TCB Review Comments for (B06-0426c- Q87-WRT300NV1, 950420H02- Cisco 11n Router)

-EMC-

CH7

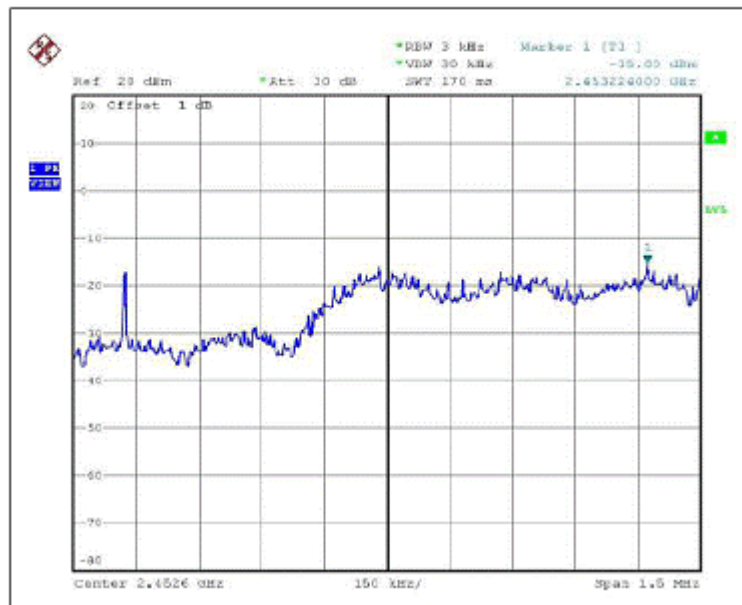
Question #1: P 136 or test report Sweep Time setting is wrong please re-take data.

=> Plot has been re-measured with correct setting and test report updated.
